SERVICE INFORMATION NO. SI 40NG-048

Andair Fuel valve system with extension

SERVICE ALERT

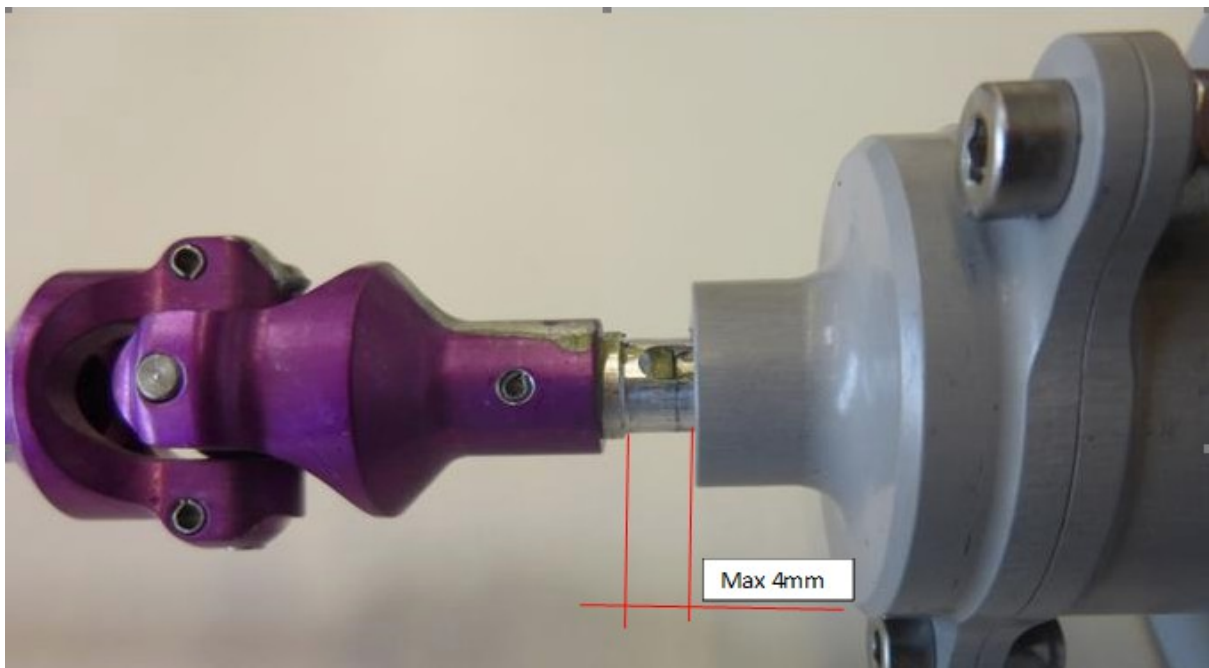
This Service alert applies to all Diamond Aircraft fitted with this extension system. It has been brought to our attention that there could be a possible lack of engagement between the universal joint assembly and the top of the valve assembly. It is requested that a check be carried out to establish a minimum of engagement of 5mm with the dowel in the valve assembly. The picture below gives a maximum dimension of 4mm. Less than this can be considered satisfactory, this gives over 5mm engagement. Greater than this, the assembly should be investigated further and a new longer dowel be fitted. The longer dowels can be supplied.
